RE: CLC FRONT STREET ACCESS / CN TOWER PLAZA DESIGN-BUILD PROJECT

REQUEST FOR QUALIFICATIONS issued September 01, 2011

1. The following revisions are incorporated into the Request for Qualifications (RFQ) prior to close of the RFQ, and in accordance with the conditions of the RFQ.
2. Description of Addendum:

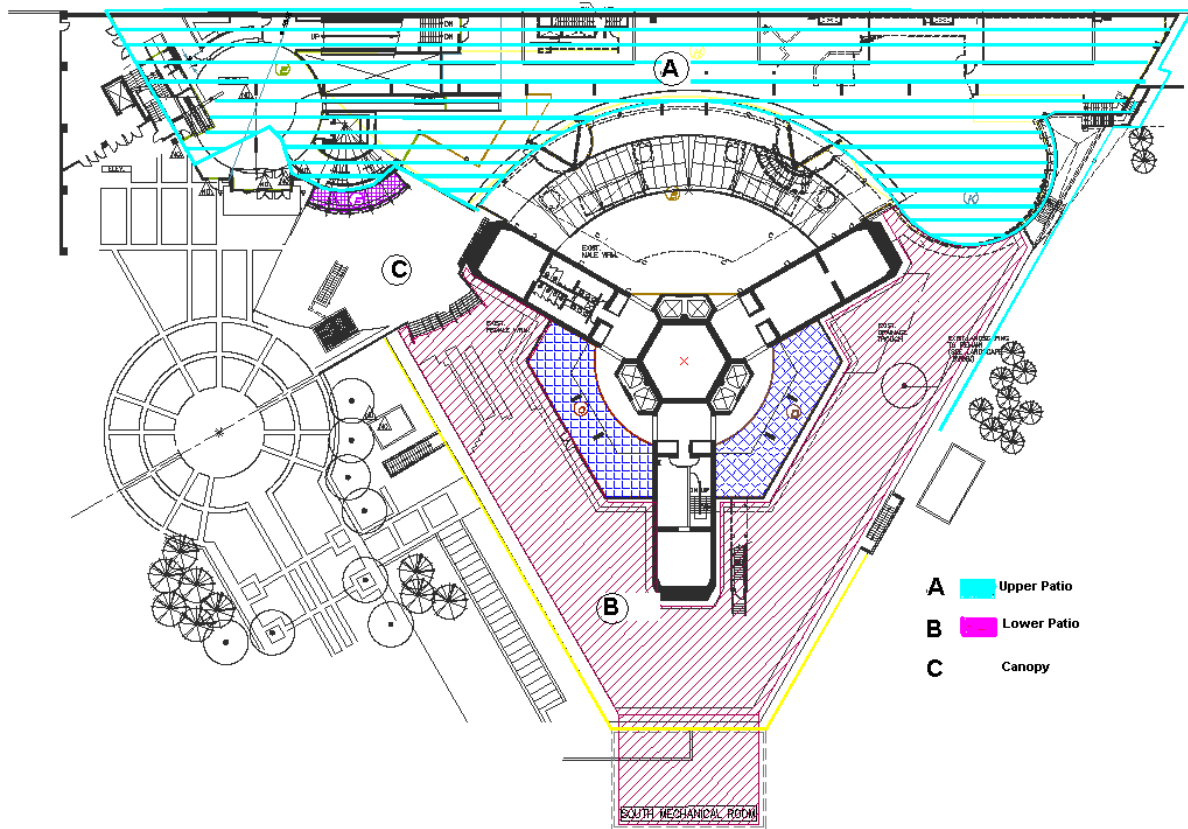
Section 2.3.2 on page 4 of 49 under Site:

Add the following words and image:

“Additionally, the CN Tower Upper and Lower Plaza areas for which CLC is seeking improvements are illustrated below:”
